Client	Furtho Development Objection Group		Page No.	1 of 24	
Project	Furtho Pits, Old Stratford, Northamptonshire		Project No.	23/115	
Subject	Review of Planning Application		Document No	TN001	
Prepared By	MK	Checked and Authorised By	MK	Date	July 2023

1.1.1 Velocity Transport Planning (VTP) has been appointed by the Furtho Development Objection Group to undertake a review of the highways and transportation technical information submitted in support of the Planning Application at Furtho Pits, Old Cosgrove Road, Old Stratford, Northamptonshire (Planning Ref: WNS/2022/1741/EIA).

Figure 2-1: Planning General Arrangement

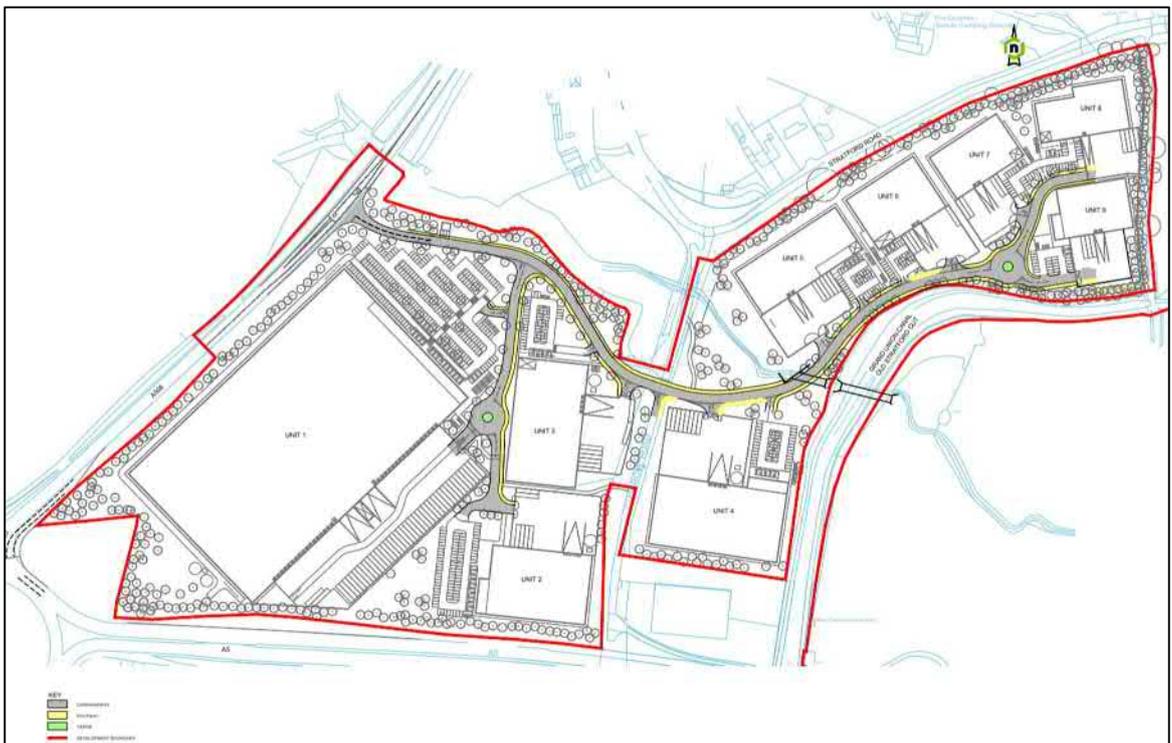
2.2.3 The General Arrangement Plan shows a single point of access from the A508 at a point approximately 50m to the south of the nearby culvert that provides a pedestrian link underneath the A508.

2.2.4 It is key to note that Cosgrove Road currently provides a vehicular access to an existing commercial unit (Jade Tyres) that will form part of the future development. Cosgrove Road also provides a means of access to an existing farm via a route that passes through the culvert on the A508. As the primary access road does not provide a link to Cosgrove Road, it must be assumed that the proposed development will not hinder this existing means of access to the farm. However, this is not clear from the General Arrangement Plan.

Figure 2-2: Proposed Site Access Junction

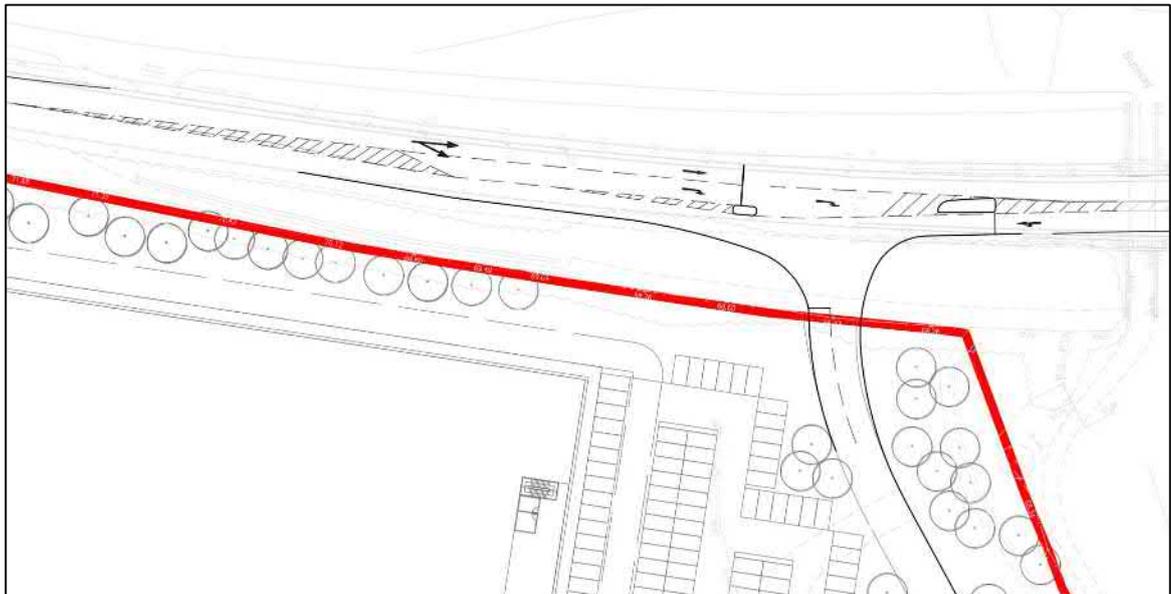
- 2.2.7 The initial consultation response from WNC dated 10/10/2022, commented that the signal junction arrangement was presented as an indicative proposal as part of the original application. This was due to the fact that traffic count data from the Northamptonshire Strategic Transport Model (NSTM) was not available at the time, and therefore it was not possible to undertake the capacity assessments that would establish the exact junction type and geometry that would be required.

- 2.2.8 Following the submission of the TAA, which included the capacity assessment of the proposed traffic signal junction with data obtained from the NSTM, WNC provided a further consultation response dated 02/03/2023. WNC stated that there had not been adequate justification for the provision of a traffic signal junction, which would lead to unjustified and unnecessary delays along the A508.

- 2.2.9 In addition, WNC noted that whilst not referred to within the TAA, Note 2 of the Proposed Site Access Junction Plan (a copy of which is included in **APPENDIX B**), states “As an outcome of the initial modeling work and due to capacity, it is proposed to reduce the speed along the A508 from Old Stratford roundabout within the vicinity of the proposed site access to 30mph (to be agreed with the Council).”

- 2.2.10 As the A508 is currently derestricted, and as such, has a speed limit of 60mph, this reduction in speed limit would not only require approval from the highway authority, but would also require a formal Traffic Regulation Order (TRO) to be progressed. As a permanent TRO is subject to separate consultation, which in this instance is considered would only take place after the granting of planning permission, there is no guarantee that the reduction in speed limits from 60mph to 30mph would be acceptable. As such, the junction proposals may not be deliverable if the TRO process is not successful.

- 2.2.11 WNC also noted within their March 2023 consultation response that the proposed site access junction had not been the subject of a Stage 1 Road Safety Audit (RSA). As such, it was the highway authority’s view at the time that, subject to further capacity assessments and a Stage 1 RSA, insufficient justification had been provided for the proposed traffic signal junction arrangement.

Figure 2-3: Alternative Proposed Site Access Junction (T Junction with Ghost Island – One Lane Exit)

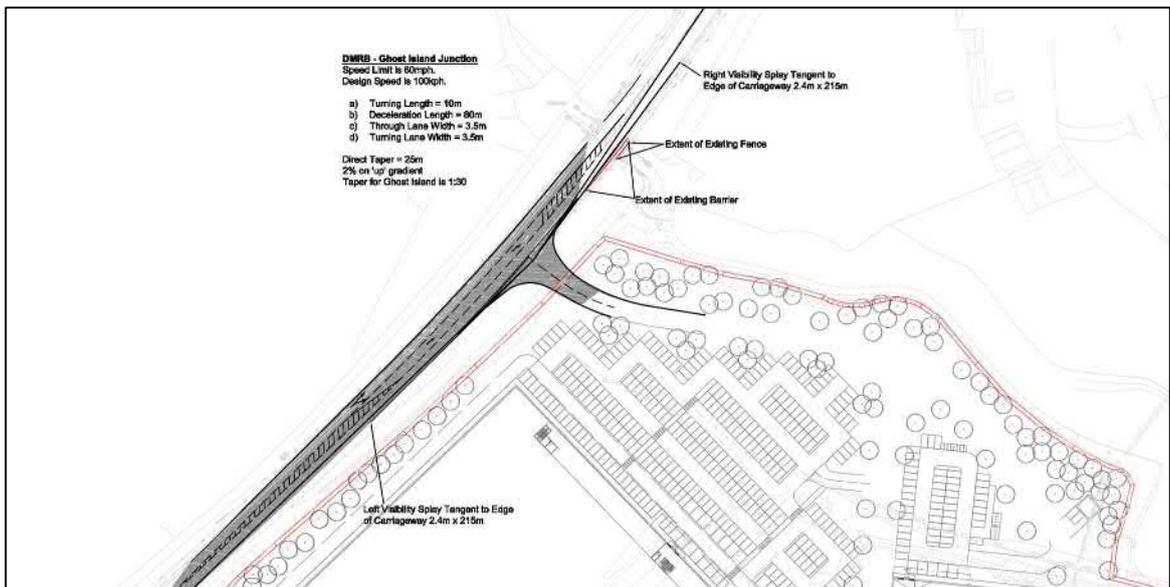
- 2.2.13 The assessment contained within TN05 concluded that a T Junction with Ghost Island would not be a suitable junction to accommodate the predicted level of traffic movements expected. For completeness, an extract of the T Junction with Ghost Island arrangement that was included within TN05 is presented in **Figure 2-3**, and a full copy is included in **ATTACHMENT B**.

Figure 2-7: Revised Proposed Site Access Junction

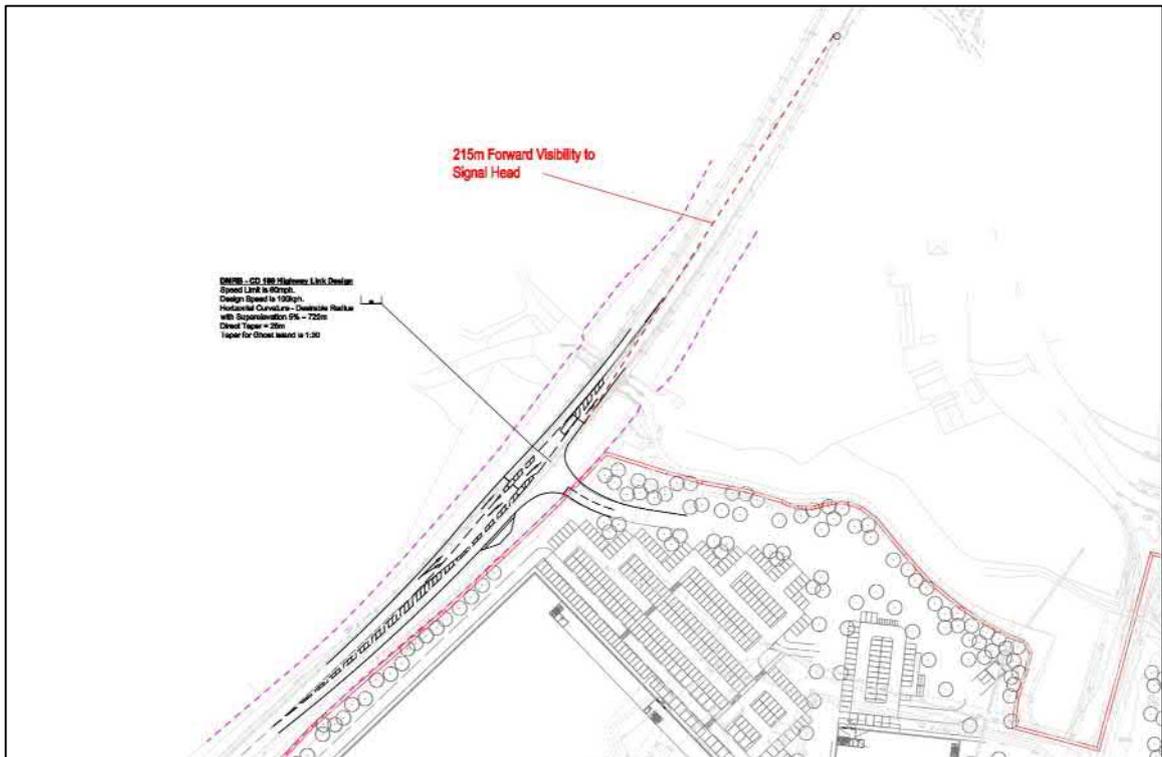
2.2.24 It is clear from the results presented above that in both the 2026 and 2031 scenarios, the DoS at the traffic signal junction is nearing 90% on a number of the approaches. The 2031 PM peak hour identifies that there is only 2.6% of practical reserve capacity (PRC) in this scenario.

- 2.2.27 The supporting technical work does not include a Stage 1 Road Safety Audit (RSA) of any of the proposed site access arrangements. As this is clearly a contentious and sensitive part of the network, it is considered that the LHA do not have sufficient information to confirm the safe operation of the potential site access junction without a Stage 1 RSA being provided.

- 2.2.29 As the Planning Application includes for access in detail, and as per the request from WNC in their most recent consultation response in March 2023, a Stage 1 RSA is required to support the Planning Application in order to demonstrate that the proposed site access arrangement is safe and suitable. As this has not been provided, it is not possible to confirm that the proposed traffic signal junction is appropriate.

Figure 2-8: Pedestrian & Cycle Access Strategy

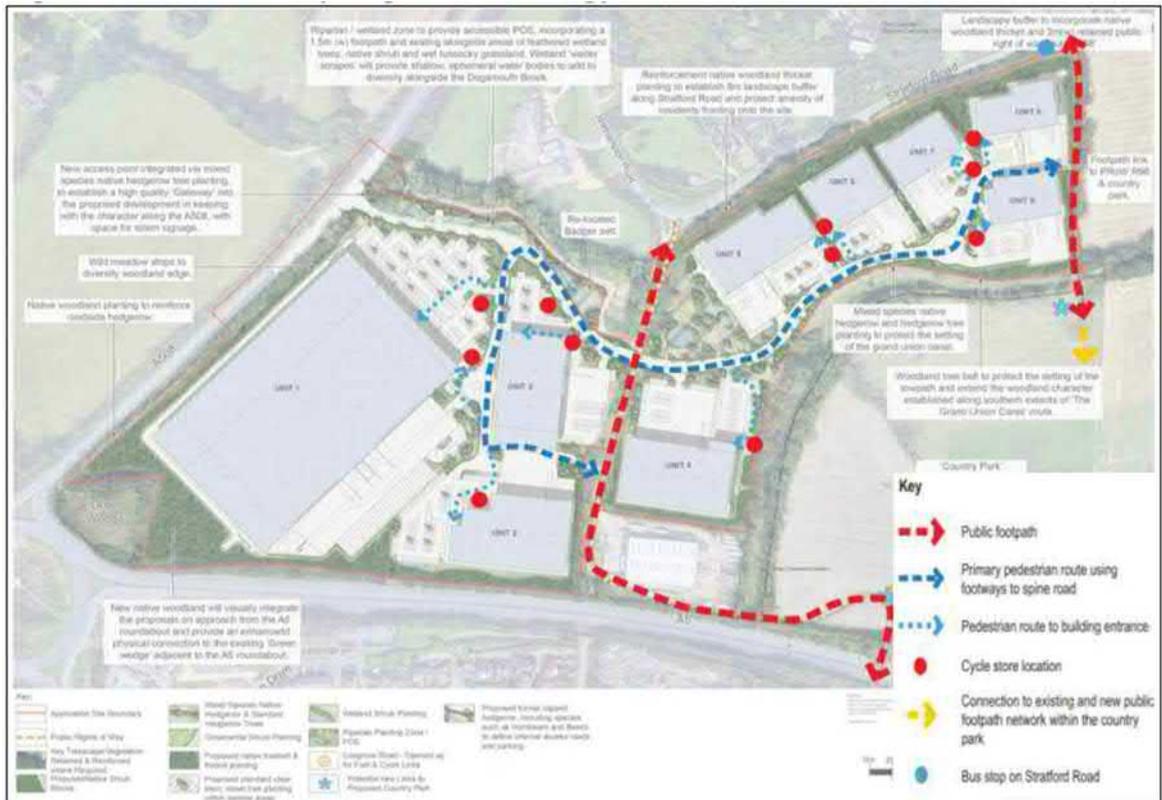
- 2.3.1 The pedestrian and cycle access strategy are commented upon within the TAA and the routes are presented at Figure 3.2 of the TAA. An extract of this is included at **Figure 2-8** for completeness.

Figure 2-9: Extract of Pedestrian/Cycle Route to Old Stratford

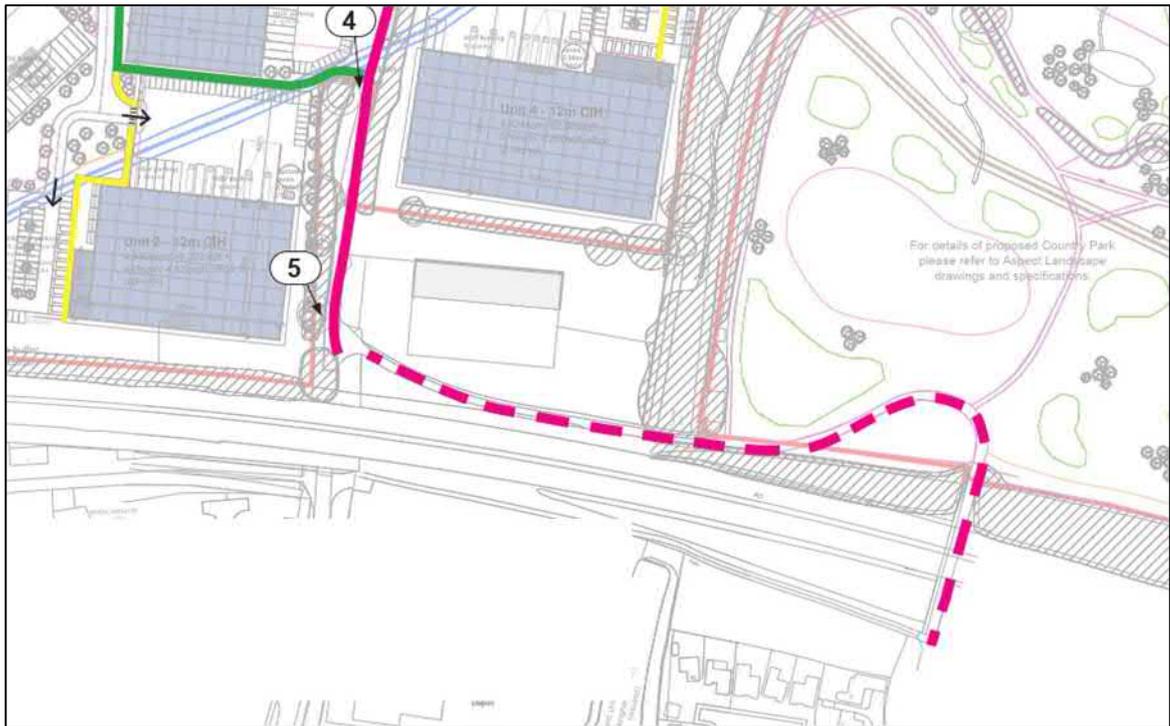
- 2.3.5 Whilst it is proposed to provide this route at 4.0m in width, which would be appropriate to accommodate shared pedestrian/cycle use, no detail has been provided to demonstrate that this 4.0m width could be provided. WNC specifically requested that detailed scaled plans be provided in this regard.

- 2.3.6 This shared pedestrian/cycle route will require an appropriate surface treatment to ensure that it can be used in all weather conditions. In addition, it will have to be lit, which may have a detrimental impact on the Country Park environment. These details should also be provided so that an appropriate assessment can be undertaken of the only realistic sustainable link to the proposed development.

Figure 2-10: Extract of Pedestrian/Cycle Route to Stratford Road via the Existing PRoW

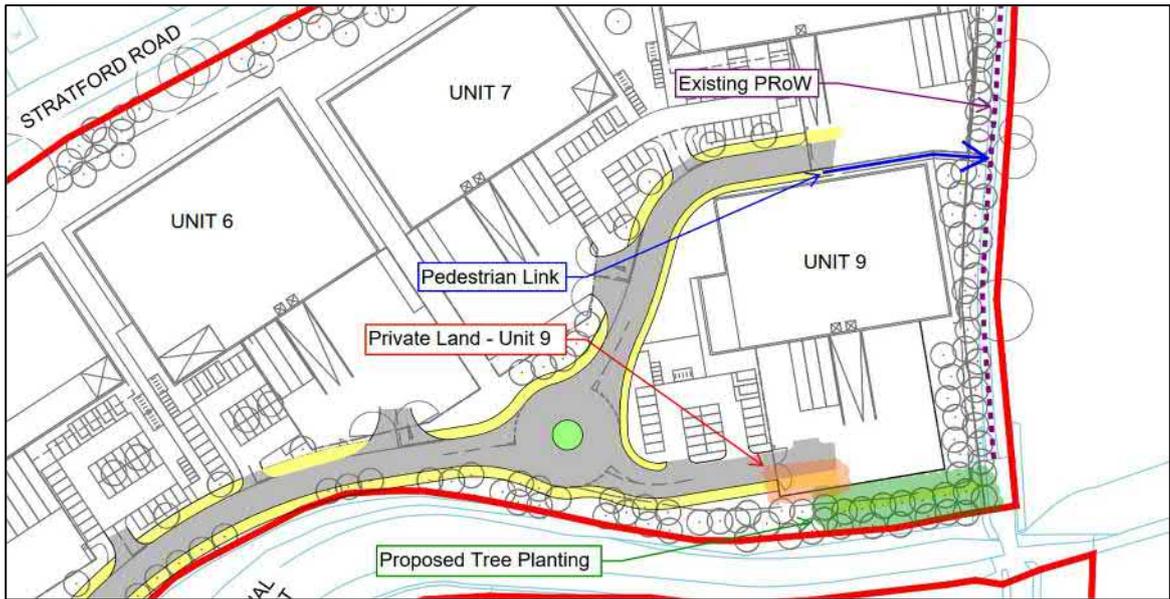
- 2.3.8 **Figure 2-10** presents an extract of the General Arrangement Plan (included at **ATTACHMENT B**), which identifies that the pedestrian connections to the existing PRoW are proposed via a pedestrian link adjacent to the internal access road to the immediate north of Unit 9, and to the south of Unit 9.

- 2.3.9 The proposed route to the north of Unit 9 is identified as being 2.0m in width, which is not considered to be an appropriate width to accommodate shared pedestrian and cycle use of this only link towards the north of the site. The proposed route to the south of Unit 9 appears to pass through a secure area that forms part of the service yard for Unit 9, which means it will have limited access for pedestrians, and also appears to pass through an area of new planting.

Drawing
**PLANNING
GENERAL ARRANGEMENT**

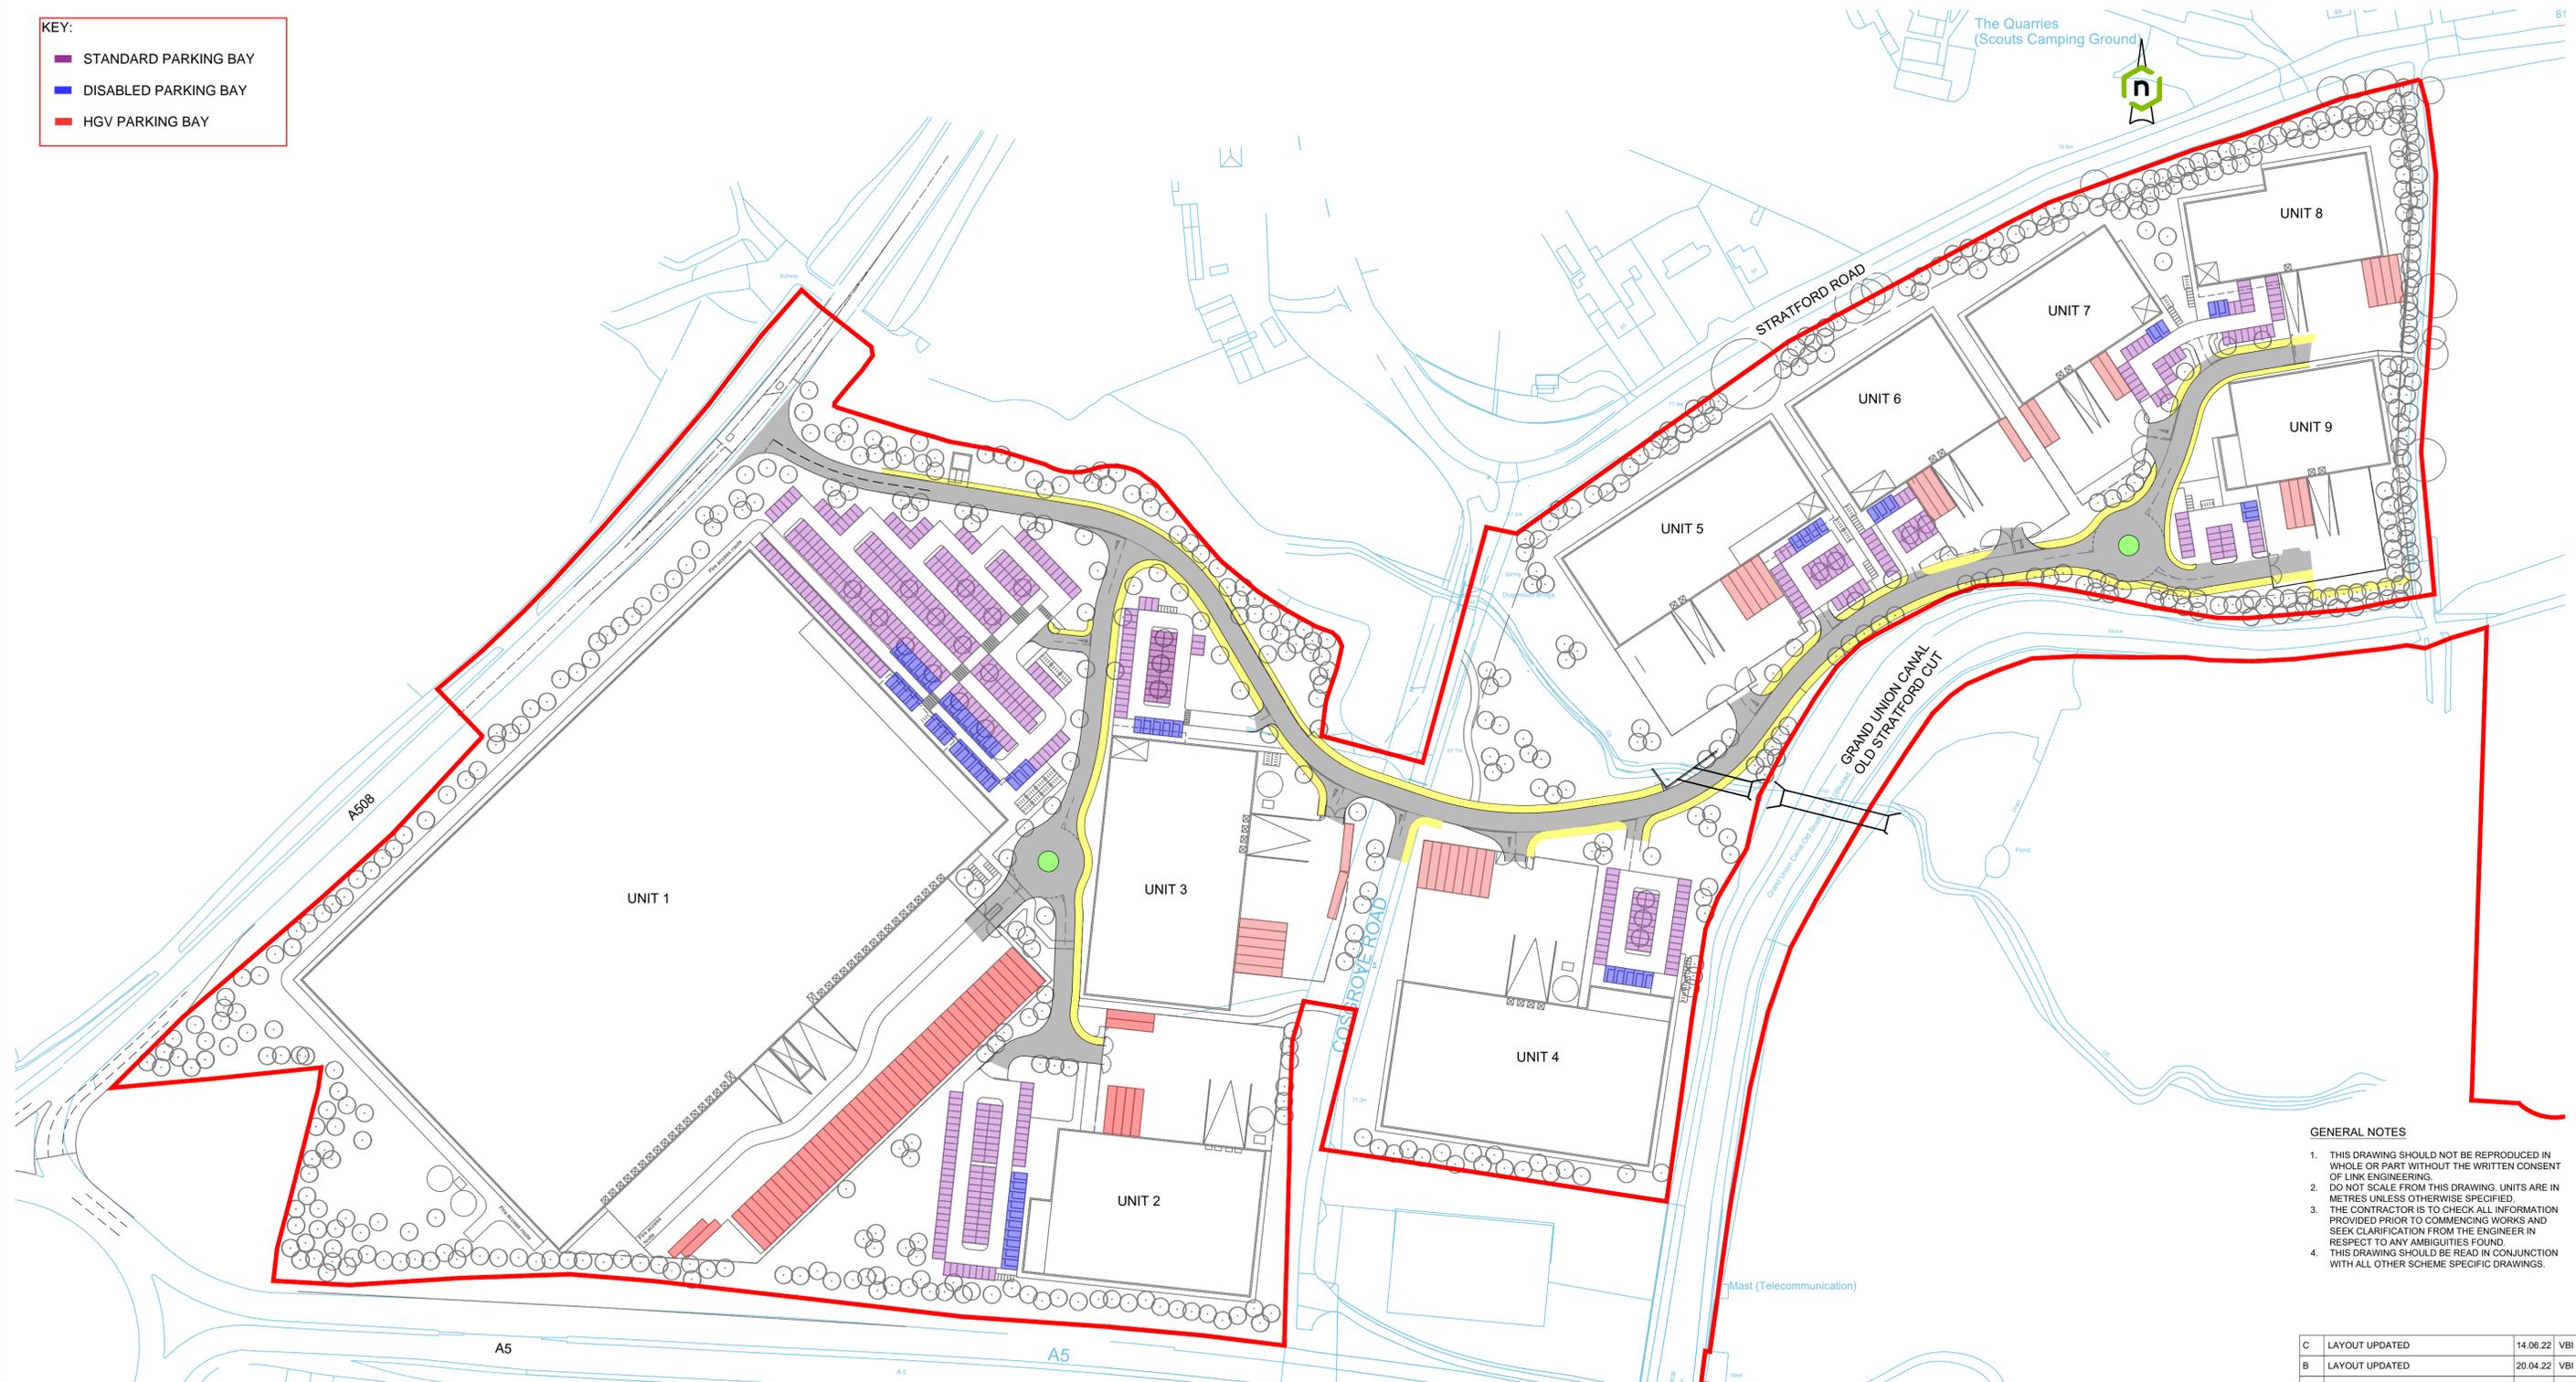
2.7.4 A review of the actual parking provision based on the General Arrangement Plan has been carried out and this plan is presented in **ATTACHMENT E**. **Table 2-3** sets out a summary and comparison of the parking requirements based on the standards for the respective land use, the provision identified in the TAA tables by BWB, and the actual provision based on a review of the General Arrangement Plan. For completeness, the difference that is presented is a comparison of the actual provision and the requirements identified in the parking standards for the respective land uses, and floor area.

2.7.5 The actual parking provision for the majority of Units does not meet the parking standards, particularly if the most onerous approach to land use is taken. With the exception of Units 5 and 7, all are providing less than required, and in some instances considerably less. On average, the proposed development is identified to provide a shortfall of approximately 210 car parking spaces, which equates to an average shortfall of approximately 25%.
